The potential application of the TfL Direct Vision Standard in UNECE regulation – **Response to ACEA limit values**

Loughborough University Design School (LDS): Design Ergonomics Research Group
Research Sponsored by Transport for London and the UK Department for Transport

Analysis of Cat A – ACEA proposal (8.5m³) DAF CF (highest)

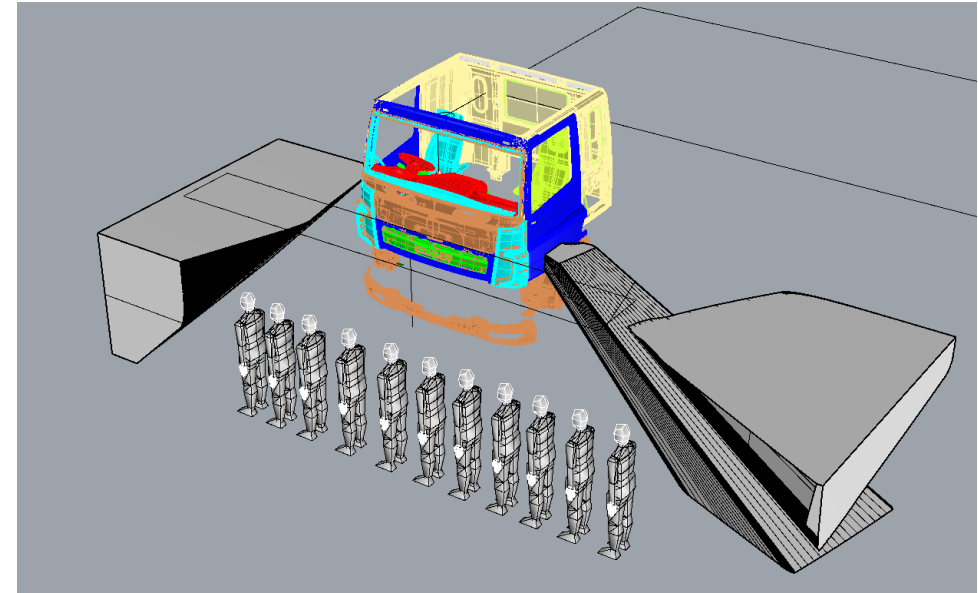
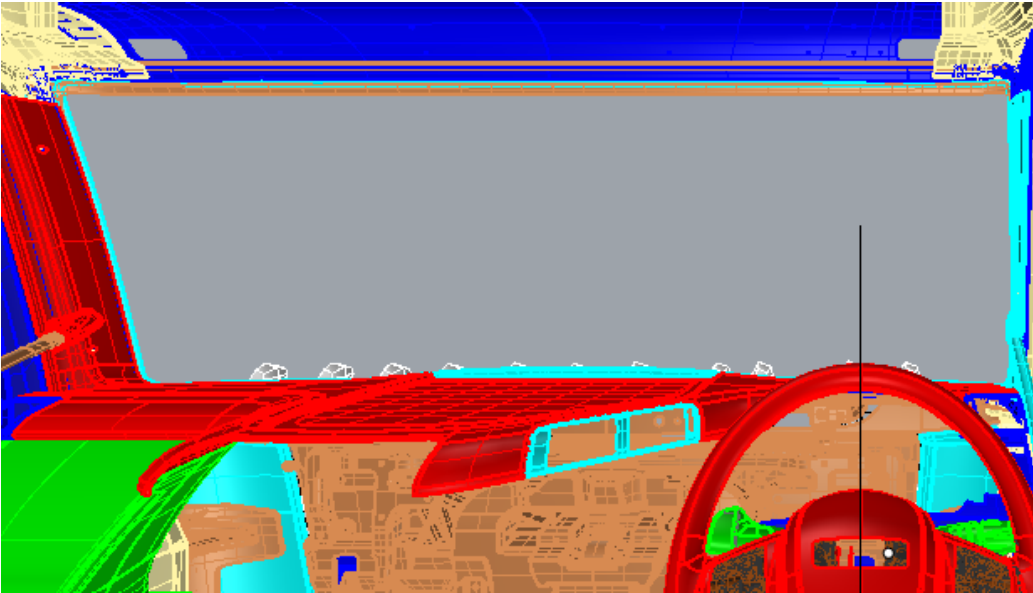
- All of these VRUS are partially visible to the driver of this vehicle. At the edge of the Class VI mirror zone
- Some only have a very small section of the head visible

Analysis of Cat A – ACEA proposal (8.5m³) DAF CF (highest)

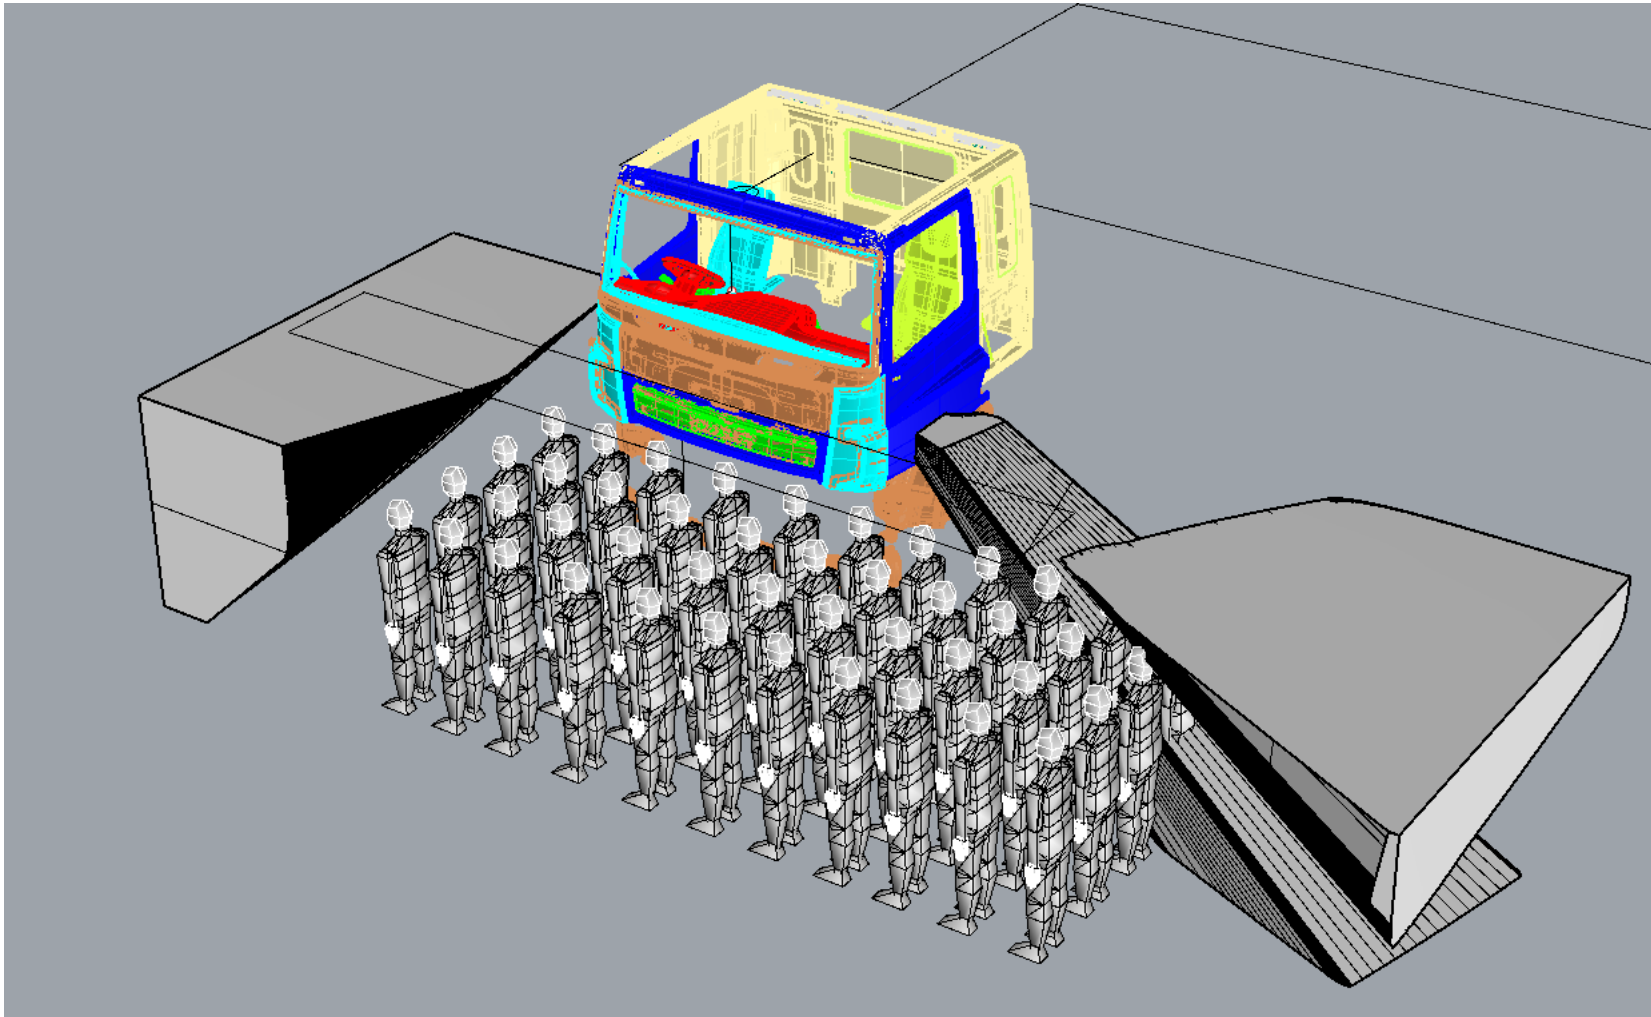
- If the driver does not use the class VI mirror all of these VRUs are not visible to the front
